Date Created: 12/22/2003
Date Issued: 1/20/2004
PCN # 20035102

INFORMATION ONLY NOTIFICATION

PCN Type: Marking Format or Content

Change To: DO-35

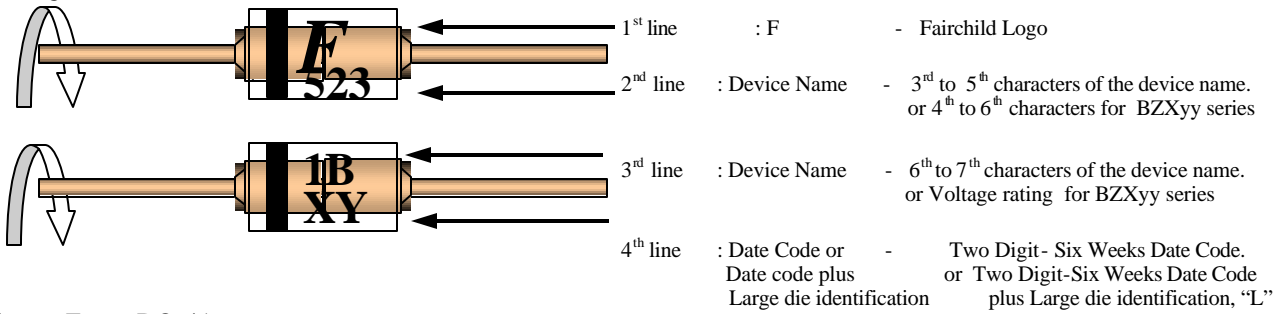
Date code marking will be implemented to improve the traceability of the parts. This additional marking content will ensure a fast turn-around of historical problem verification, better control for containment actions and improve visibility of implementation dates for corrective actions.

The following revisions will be implemented:
